ADDENDUM NO. CC-2

TELEGRAPH DISTRICT
401 BUILDING RENOVATION
LINCOLN, NEBRASKA
DLR GROUP PROJECT NO. 10-16202-00
MARCH 18, 2016

COMBINED CONTRACT

REFLECTED CEILING PLAN, THIRD LEVEL
TELEGRAPH DISTRICT
401 BUILDING RENOVATION

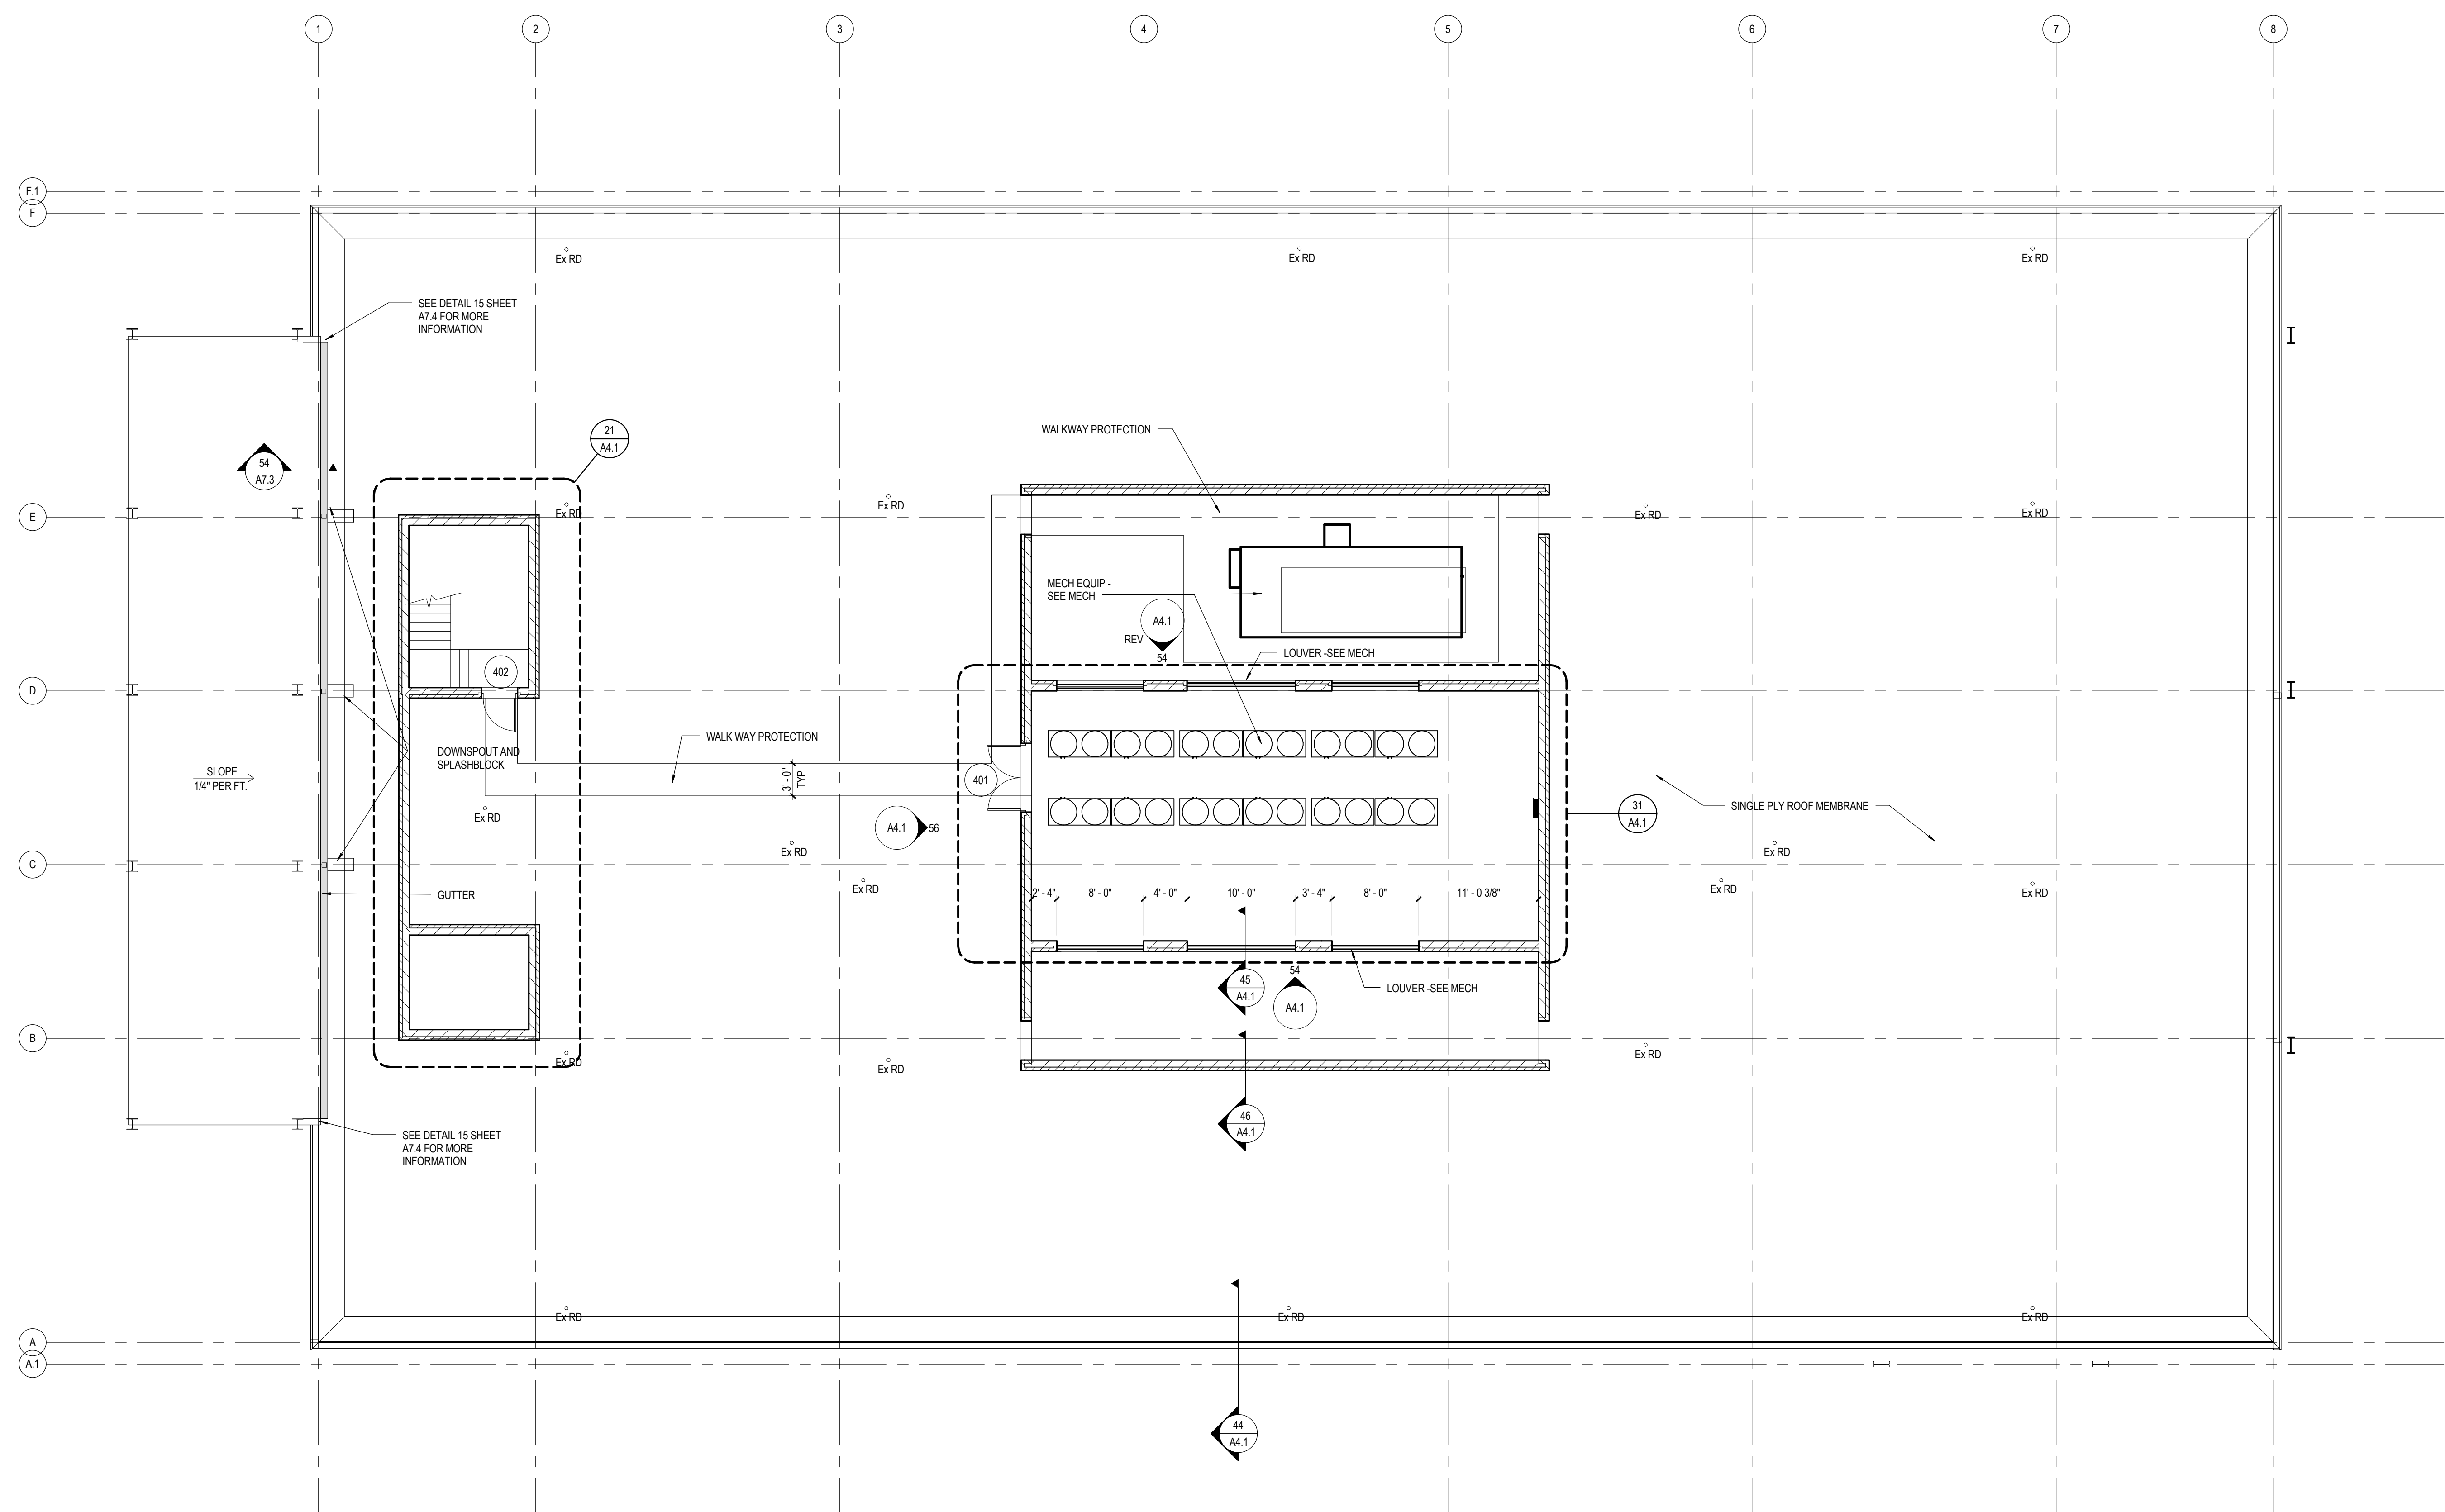
ITEM NO. 6 DRAWING A3.3 REFLECTED CEILING PLAN, THIRD LEVEL

- A. Revised drawing showing Sound Absorbing Ceiling Units.
